**MEMORANDUM**

**TO:** District of Columbia Zoning Commission

**SUBJECT:** **Public Hearing Report** for ZC #11-03J, Wharf Parcels 6 through 10  
First Stage PUD Modification and Second Stage PUD Application

Approved 1<sup>st</sup> Stage PUD site plan, including pier and dock layout

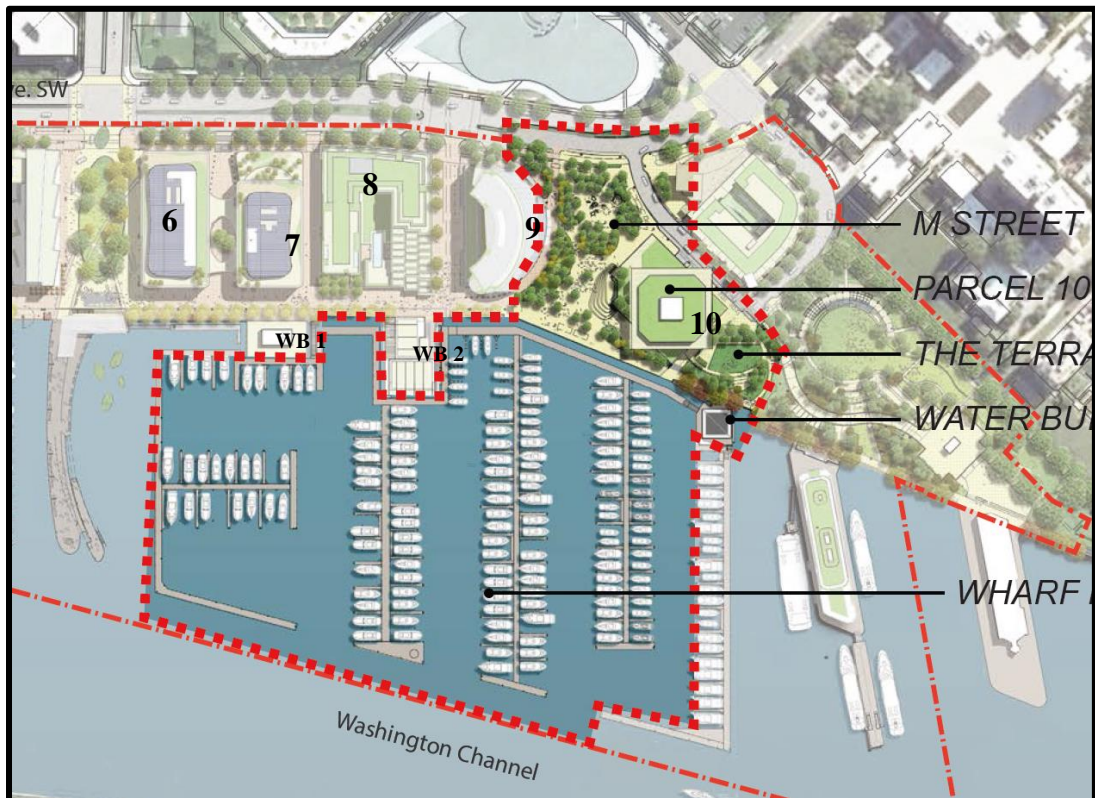
**Water Building 3 and Wharf Marina** - In response to OP and Commission comments at setdown, the applicant has requested a PUD modification for the layout of the piers, docks and water buildings. The approved first stage PUD showed a large “Commercial Pier” in the location of the current Pier 3 (the Cantina Marina Pier), which would be a rehabilitation of the existing pier or an in-kind replacement, along with an expansion. The Commercial Pier would have had a 2-story retail pavilion. As currently proposed, the water side would have no commercial pier, but would instead have docks comprising the **Wharf Marina**. The cruise boat operations formerly slated for the Commercial Pier have been moved to Pier 4, and many of the retail functions seem to have moved to Water Building 2, which has increased considerably in size.
